STATE OF CONNECTICUT
CONNECTICUT SITING COUNCIL

APPLICATION OF NORTH ATLANTIC
TOWERS, LLC and NEW CINGULAR
WIRELESS PCS, LLC (AT&T) FOR A
CERTIFICATE OF ENVIRONMENTAL
COMPATIBILITY AND PUBLIC NEED FOR
THE CONSTRUCTION, MAINTENANCE AND
OPERATION OF A TELECOMMUNICATIONS
TOWER FACILITY AT 655 BASSET ROAD IN
THE TOWN OF WATERTOWN

DOCKET NO. 422

RESPONSES TO SITING COUNCIL'S INTERROGATORIES

CLIENT NAME: North Atlantic Towers	SITE LOCATION: 655 Bassett Road, Watertown, Connecticut	PROJECT NAME: NAT - Watertown	PROJECT No.: 226-015
--	---	---	--------------------------------

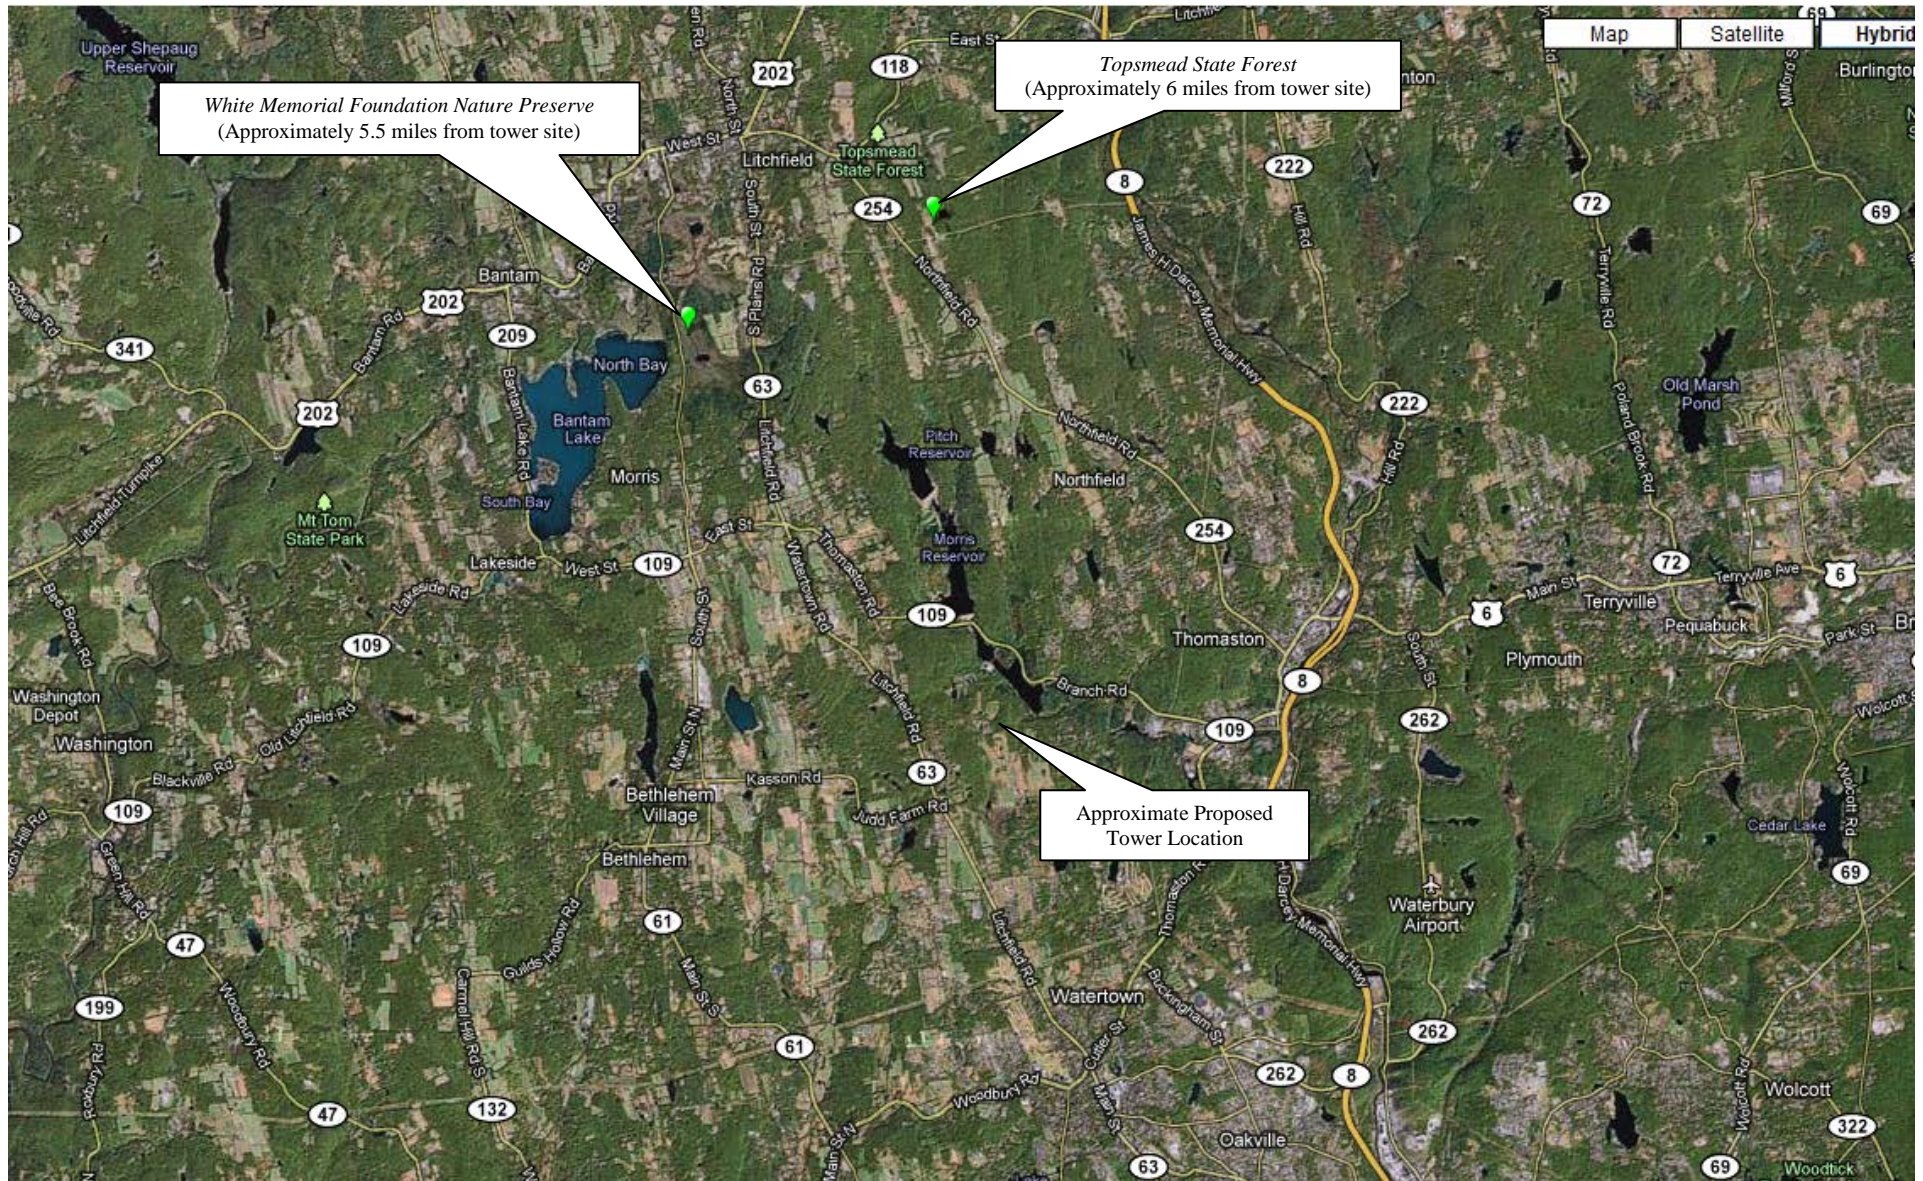
Q11. Would the proposed facility impact an Important Bird Area identified by the Audubon Society?

A11. The proposed facility will not impact any Important Bird Areas identified by the Audubon Society. As shown in the map included in Attachment 3, the closest Important Bird Area, White Memorial Foundation Natural Preserve, is located approximately 5.5 miles from the proposed facility.

AT&T Composite Coverage in Watertown, CT (Bassett Rd 1 @ 137 ft.)

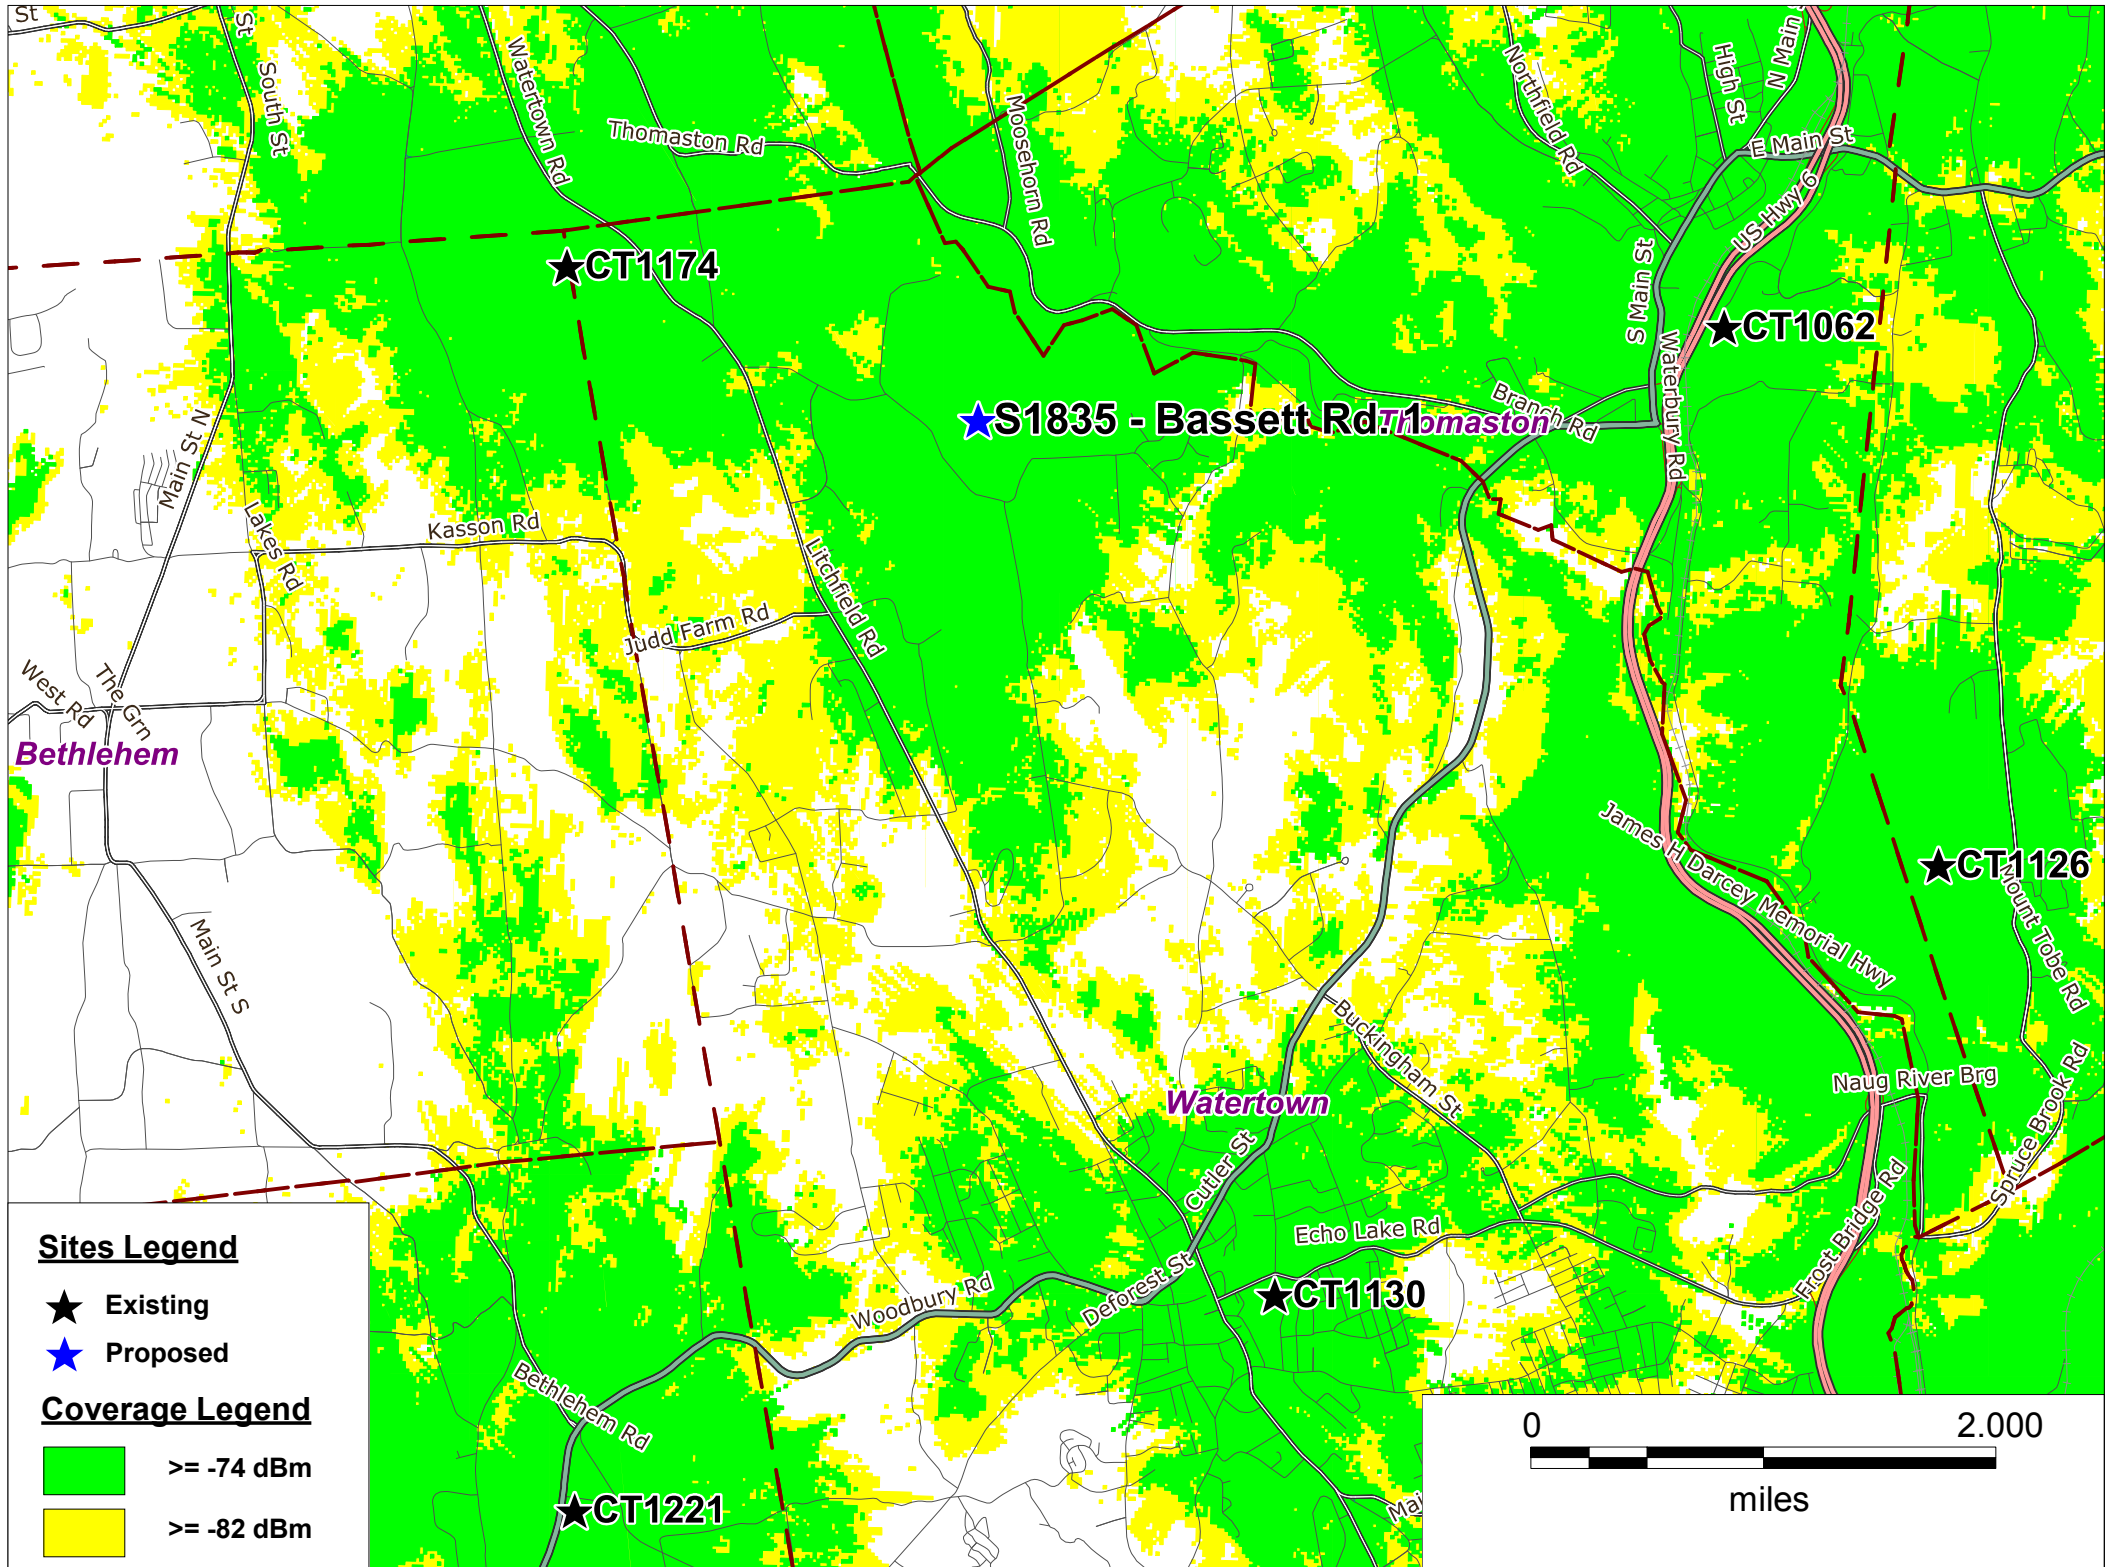
Q22. Provide a propagation map, at the same scale as those provided in the application, showing the coverage possible at ten feet below the height identified in the previous question.

A22. Included in Attachment 4 is a coverage plot showing the coverage at 137' AGL or ten feet below the minimum antenna centerline mounting height of 147' AGL.
